BLACK SPRINGS WIND FARM

INDEPENDENT REVIEW OF NOISE ASSESSMENT

REPORT NO. 06290-IP
VERSION C

DEPARTMENT OF PLANNING
GPO BOX 39
SYDNEY NSW 2001

Figure 2-3 Site Plan showing the Closest Residential Receivers

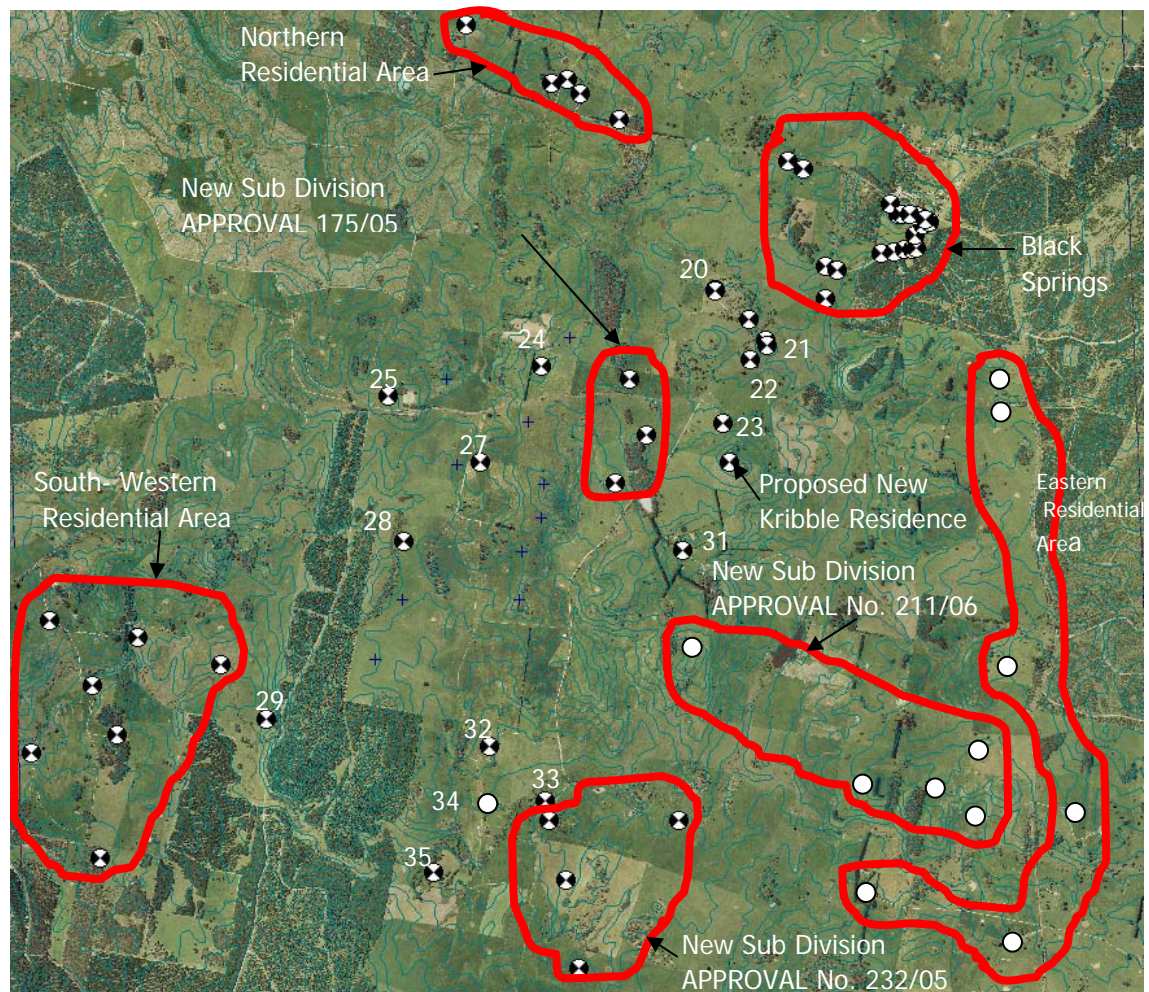
With regard to the noise predictions resented in Section 7 of the noise assessment it is stated that there are minor exceedance of 2.3dB at residence 32 and 1.6dB exceedance at residence 31. The Noise Study does investigate any noise mitigation to reduce noise levels. Residences 24 and 27 have quiet high predicted noise levels, in the order of 49.9 and 48.6dBA, respectively. These residences are contractually involved residences.

Overall the predicted noise levels from my modelling are 4 to 6dB lower than those predicted in the noise assessment. This was the result of using the new wind turbine sound power levels and conducting the calculations using the more accurate octave band calculations. However, when comparing the new predicted noise levels with my precautionary noise criteria, a noise criteria exceedance of 1.4dB at residence 32 is predicted. At the sub-division DA175/5 significant exceedances of up to 7dB are predicted.

There would seem to be three ways of mitigating the noise exceedance at residence 32, namely:

- removing wind turbine 1 from the project;
- moving wind turbine 1 from its current position and moving it to around Daisybank Shed (27); or
- using sector manager and switching wind turbine 1 off at wind speeds less than 6m/s during the night.

Table 4-7 presents predicted noise levels with wind turbine 1 being relocated to the Daisybank shed area. It should be noted that all the predicted noise levels comply with the night time precautionary noise criteria.

It is recommended that the proposed noise mitigation options be discussed with the proponent and conditioned if the project were to be Approved.

RE-ANALYSED BACKGROUND NOISE LEVEL DATA

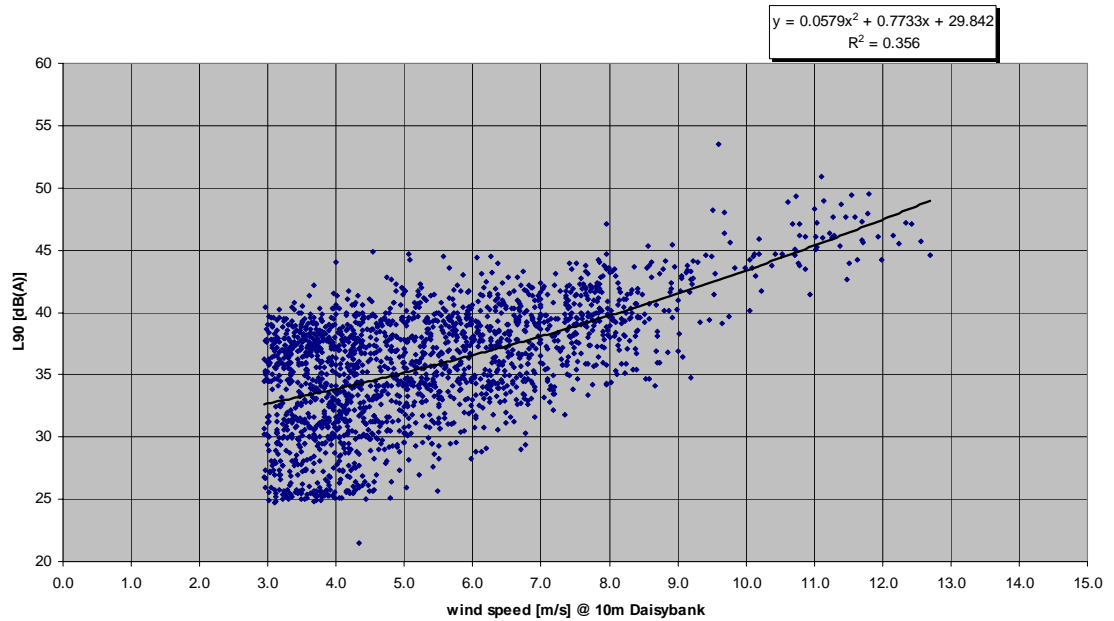
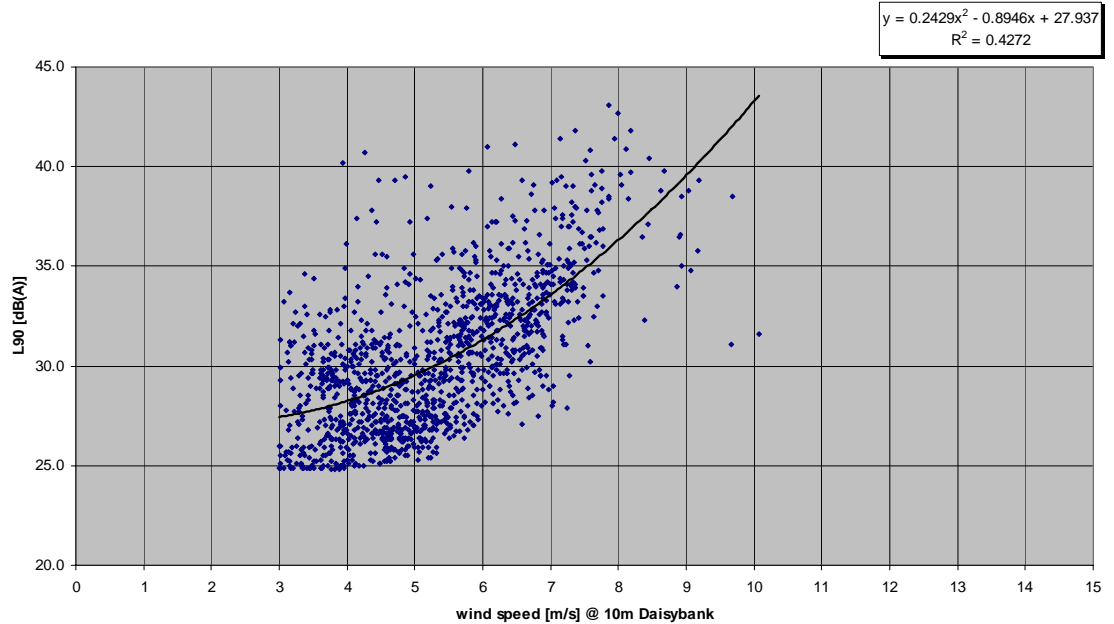
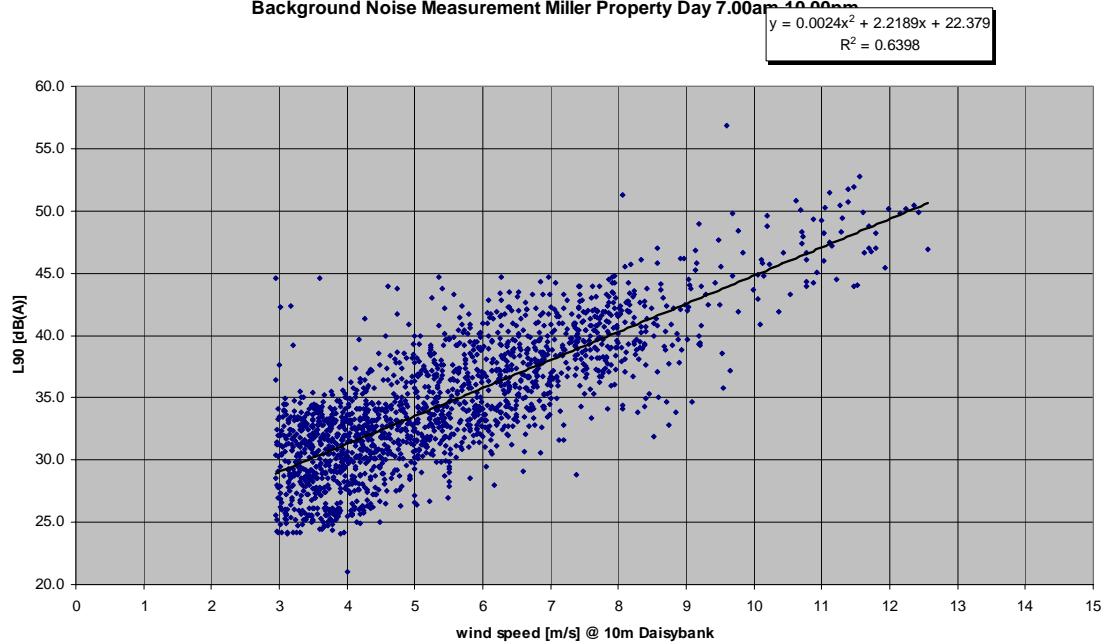
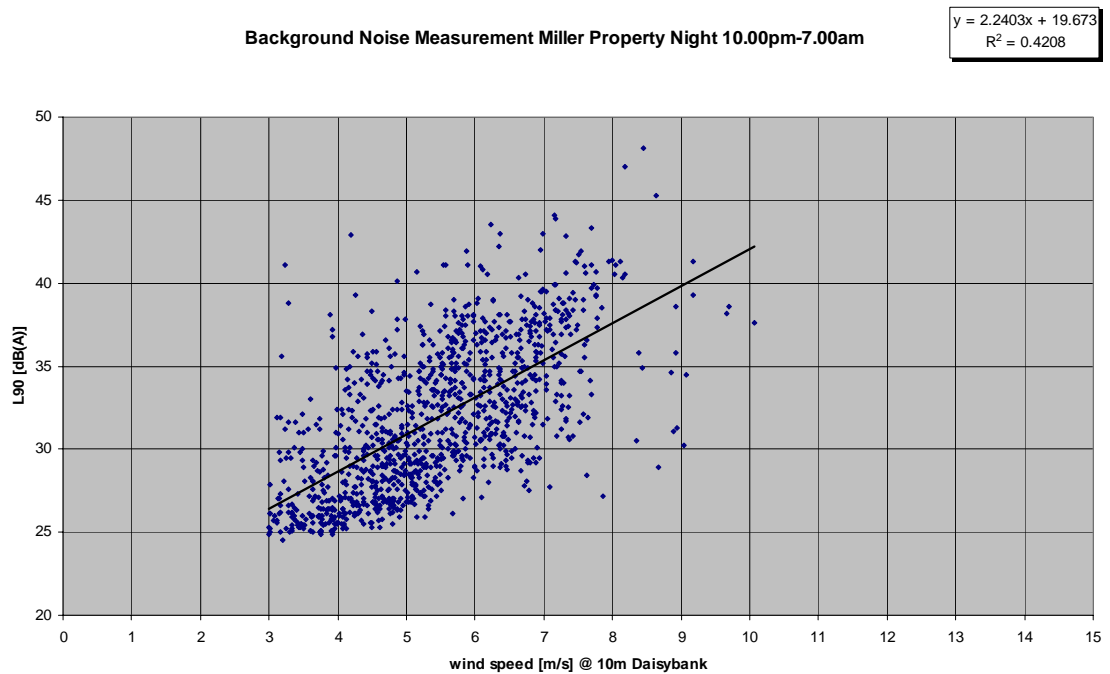
I have re-analysed the background noise data and split the data between day (7.00am to 10.00pm) and night (10.00pm to 7.00am) the wind speed verses background noise levels graphs are presented in Appendix F. Table 4-2 presents the my calculated background noise level at 6m/s (10m AGL) and 10m/s (10m AGL) calculated from new polynomials.

The analysed data from the proponent for a 24 hour period and my data are comparable for daytime with my data being slightly higher since it excludes low background levels at night. There is a substantial difference between daytime and night background noise levels, which is concern to me as the use of the 24 hour data could underestimate potential night time noise impacts.

From my experience from other wind farm noise assessments, background noise in rural environments are generally less than 32dBA at wind speeds of less than 6m/s (10m AGL) and approximately 40-43dBA between for wind speeds up to 10m/s (10m AGL). It should be noted that the daytime noise levels are substantially higher than what I would expect in such a rural environment.

Given that background noise levels were not measured at the specific closest residences likely to be affected by the proposed wind farm, the proponent has not (in my opinion) adequately considered seasonal variations in background noise levels and that my analysis of the background noise levels has indicted that night time noise levels are approximately 5dB lower at wind speeds less than 6m/s (10m AGL), then I consider the adoption of the lowest measured night background noise levels measured at the three residences should be used as a precautionary approach to apply at all residences surrounding the wind farm to gauge impacts.
